Project Code & Schematics Subject: M930 Main Board

FOXCONN		HON HAI Precision Ind. Co., Ltd.	
		CCPBG - R&D Division	
Title	Index Page		
Size	Document Number		
Custom	M930 (MBX-215)		Rev SB
Date:	Wednesday, August 12, 2009	Sheet	1 of 96

M930 (IRX-5100) Calpella Platform+ nVIDIA N11P/M Discrete Graphic

Title: **ARD&CFD (DDR3)**

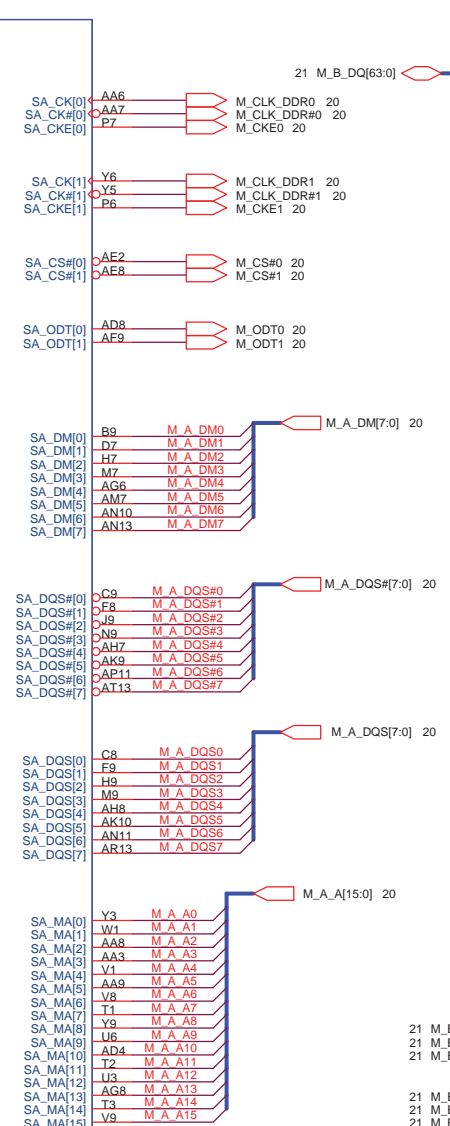
7/13 [DVT] Change to 988A socket.

7/13 [DVT] Change to 988A socket.

Express Card Slot.

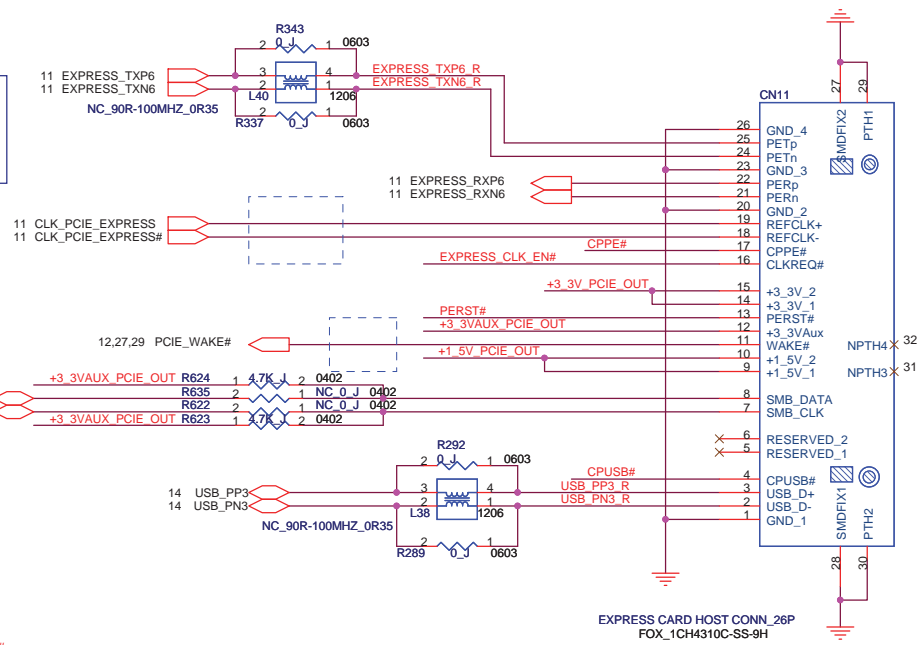
7/24 [DVT] Short R677,R683,R682,R685.

7/8 [DVT] Change the CN10 Footprint symbol for Screw PAD.

TV_FPC_CONN_50P
FOX_GB12501-10510-7H

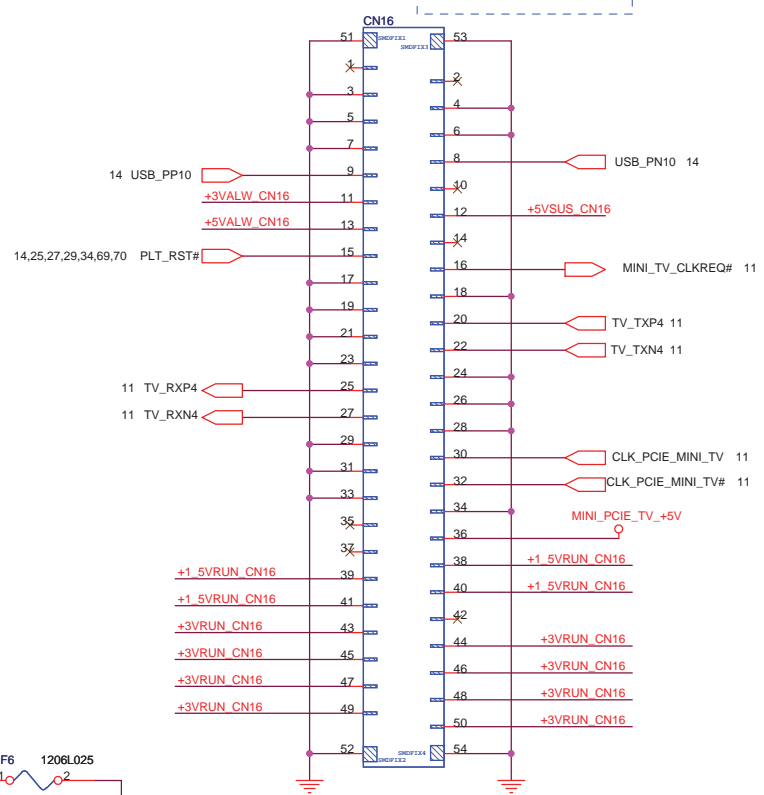
7/13 [DVT] CN16 change to GB12501-10510-7H

FOXCONN		HON HAI Precision Ind. Co., Ltd.	
Title CPU Power VHCORE		CCPBG - R&D Division	
Size A3	Document Number M930 (MBX-215)	Rev SB	
Date: Wednesday, August 12, 2009	Sheet 54	of 96

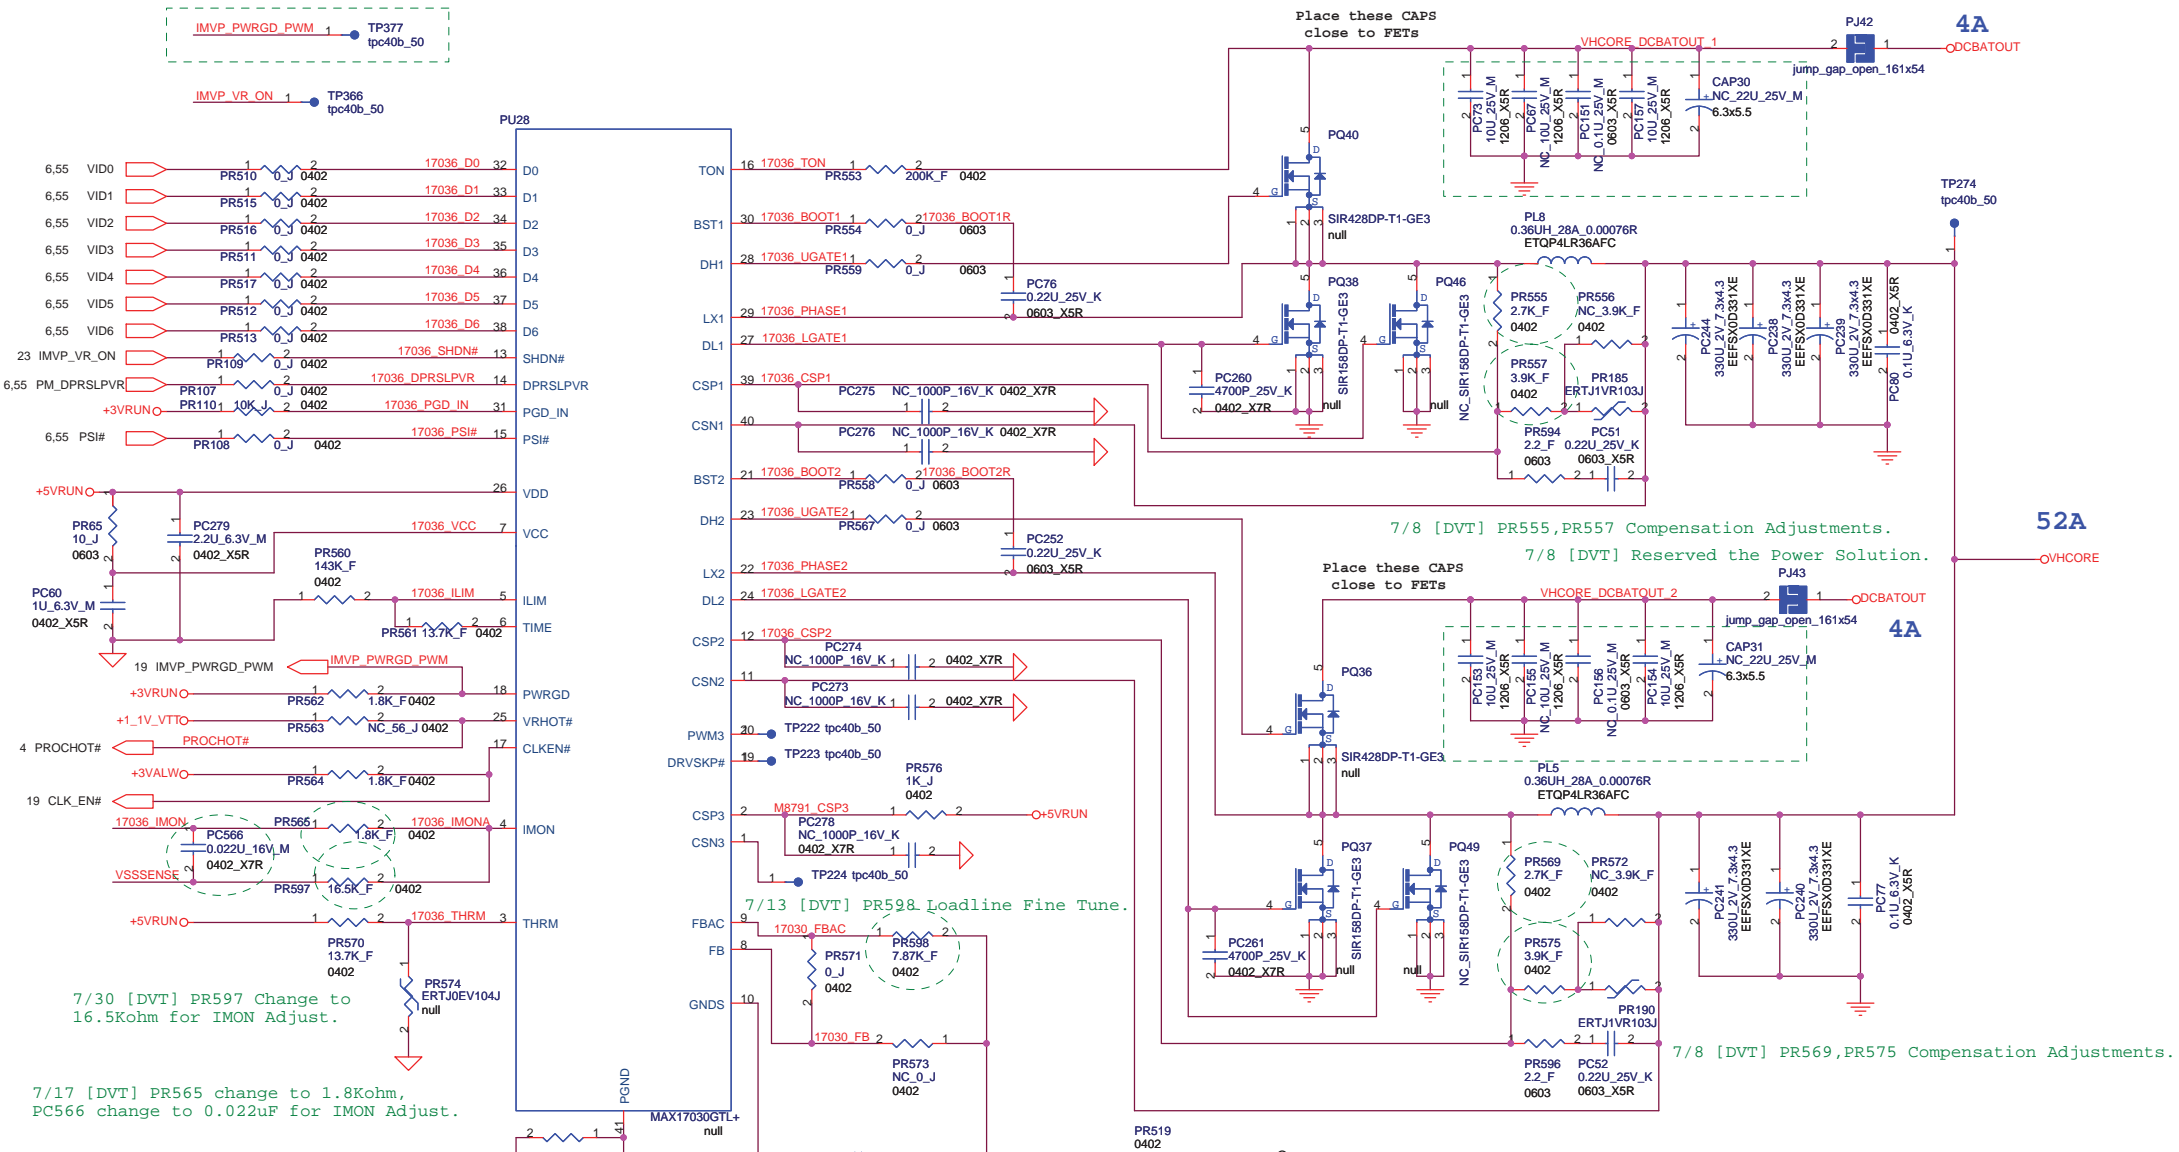
7/8 [DVT] Reserved the Power Solution.

7/13 [DVT] PR598 Loadline Fine Tune.

7/30 [DVT] PR597 Change to 16.5kOhm for IMON Adjust.

7/17 [DVT] PR565 change to 1.8kOhm, PC566 change to 0.022uF for IMON Adjust.

$$V_o = (1 + (PR222 / PR229)) * 0.8 = 1.05V$$

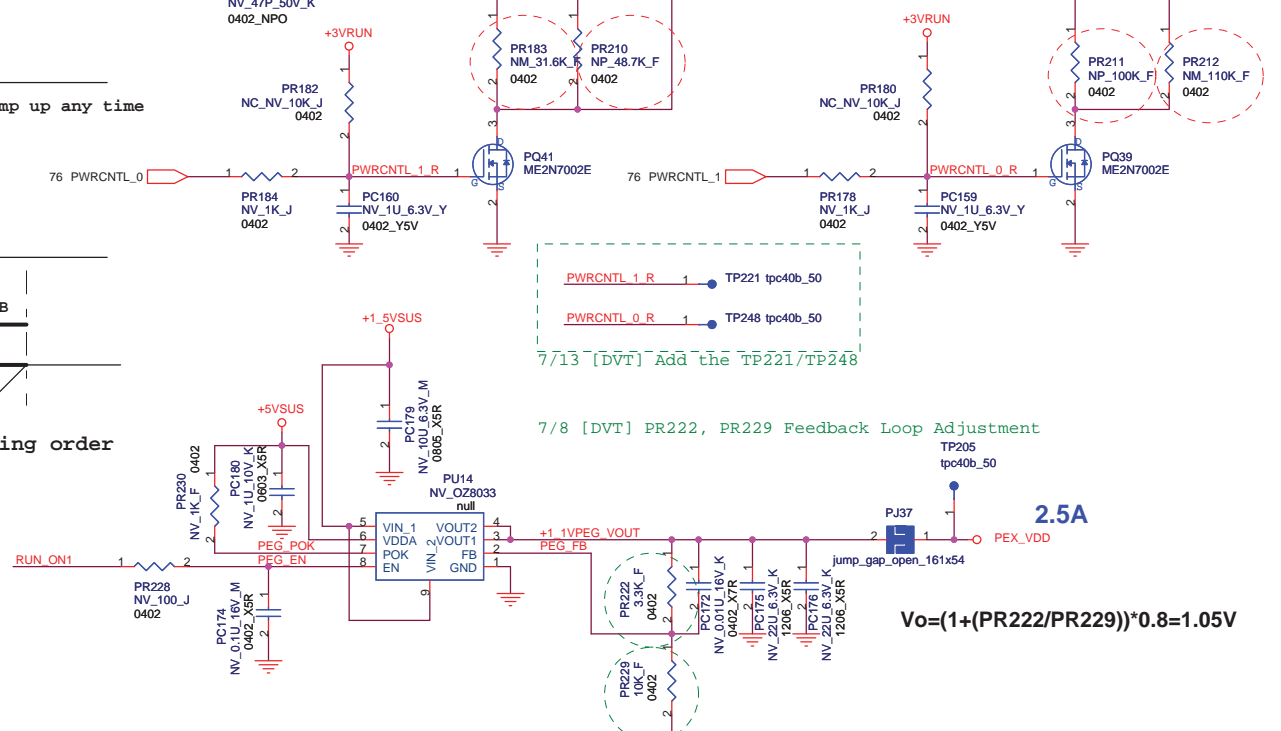
7/13 [DVT] Add the TP221/TP248

7/8 [DVT] PR222, PR229 Feedback Loop Adjustment

PC BEEP

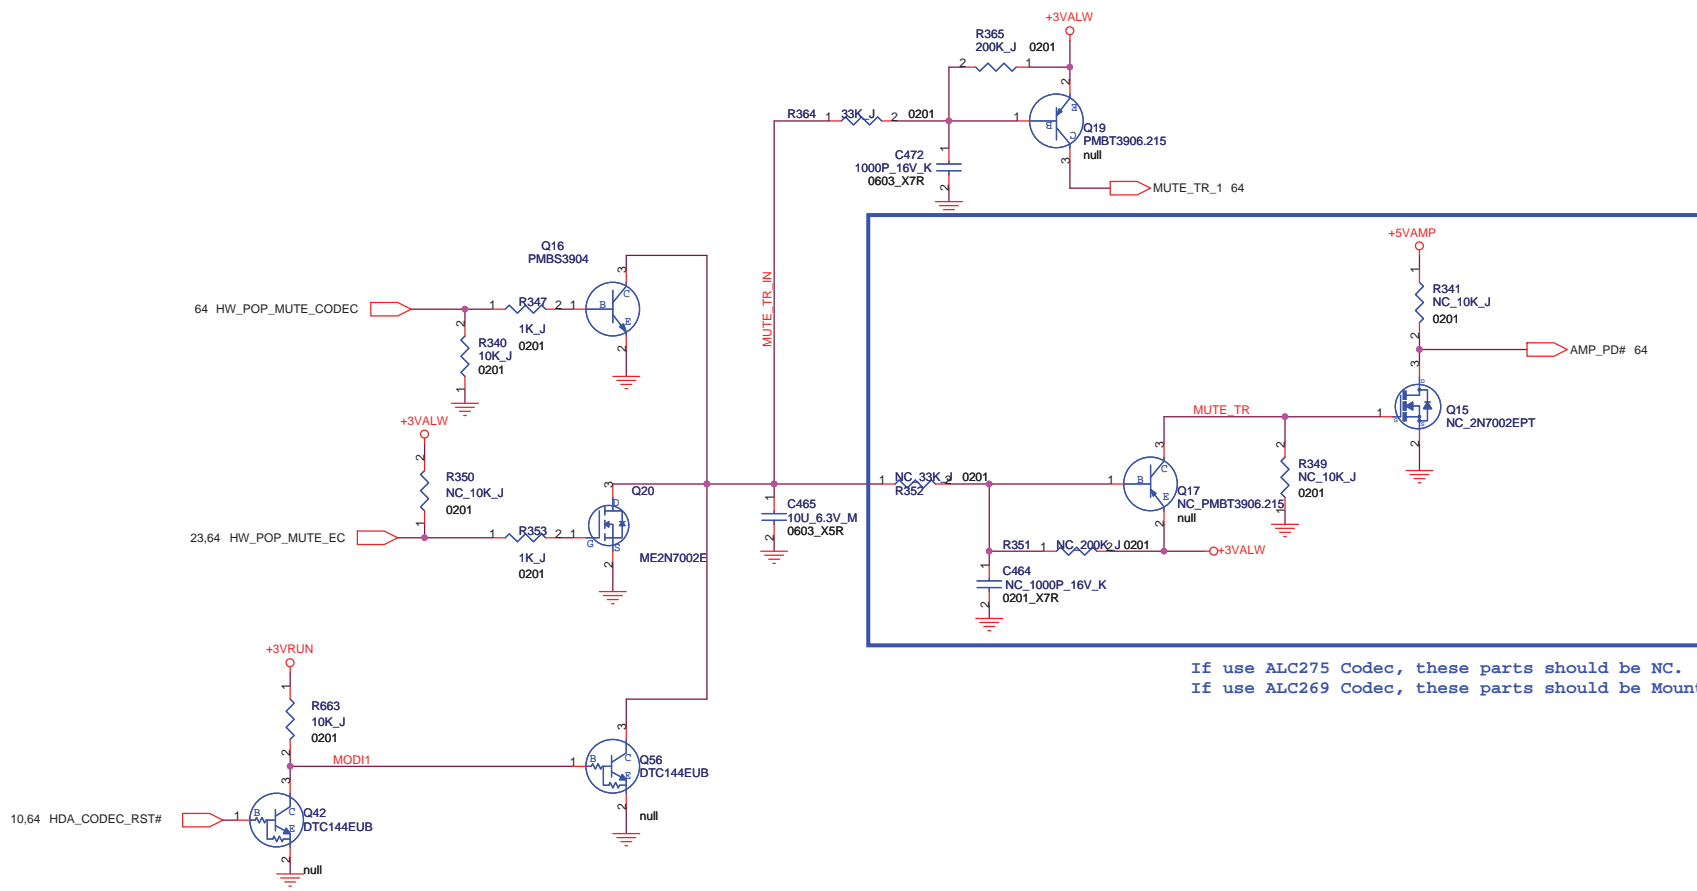
8/10 [DVT] Change R5782 to 100kohm to decrease and BEEP sound level as MOR request.

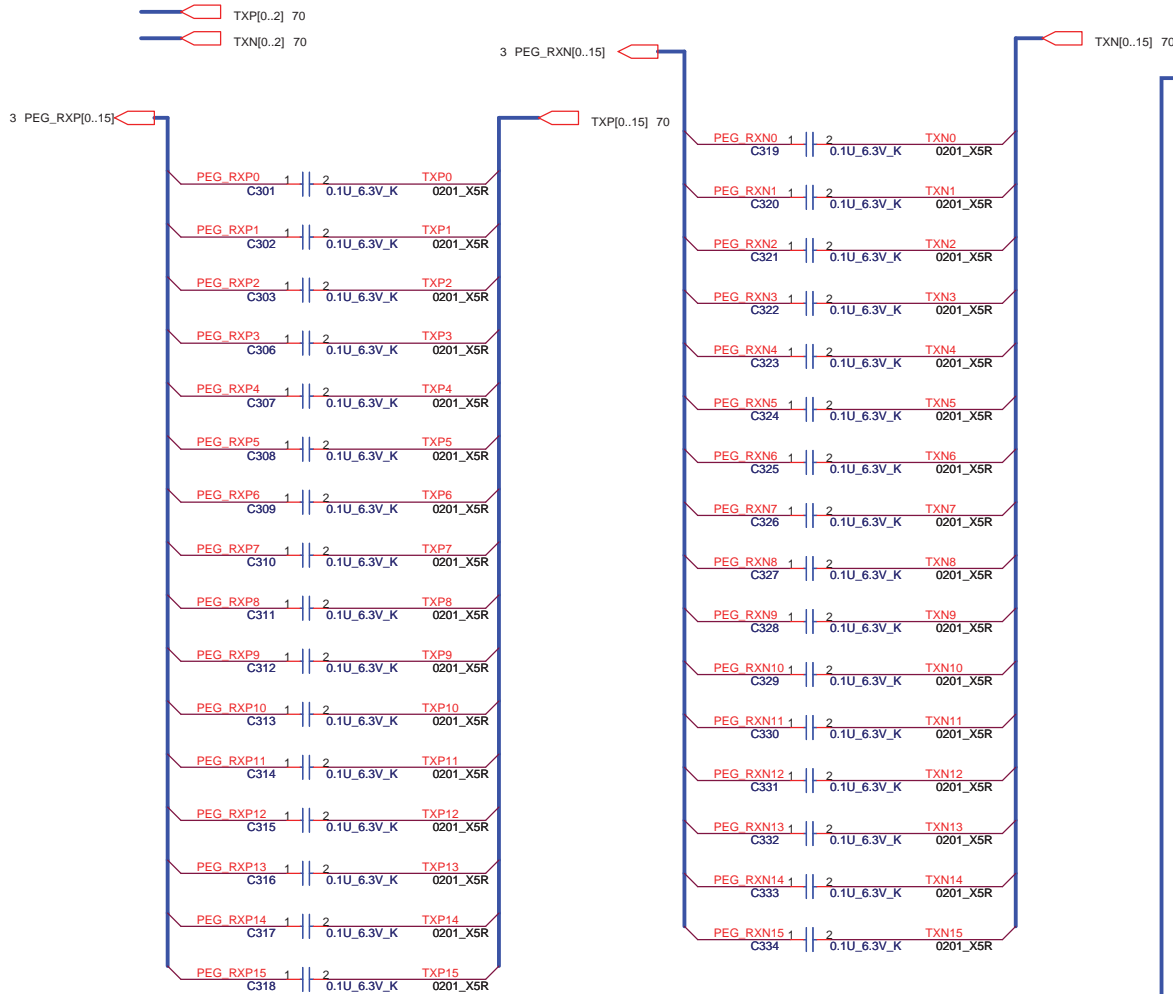
8/3 [DVT] Revise the Strap Pin value as FAEprovided for DVT Sample.
 - N11P-GE1 x0A29
 - N11M-GE1 x0A75

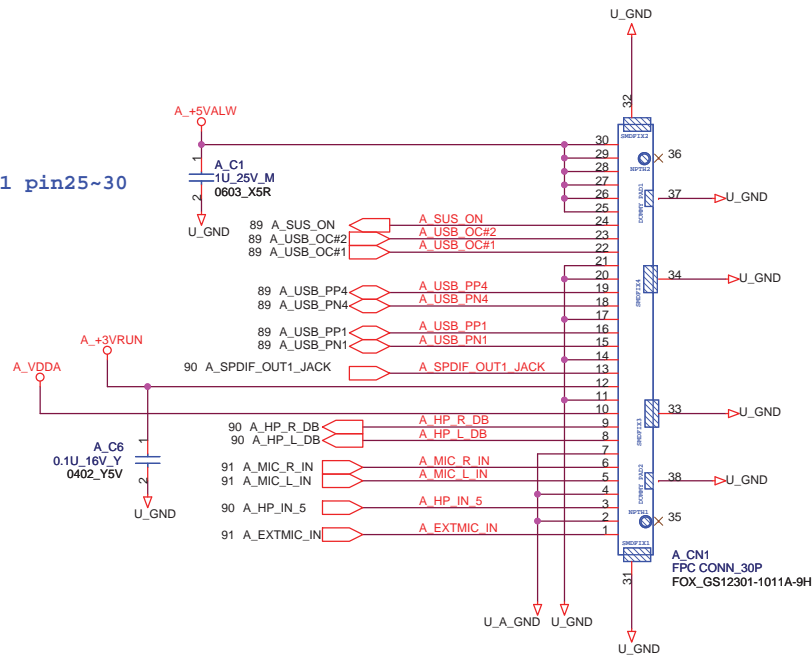
Place A_C1 close to A_CN1 pin25-30

8/5 [DVT] Add EMI Solution A_EC1-3.
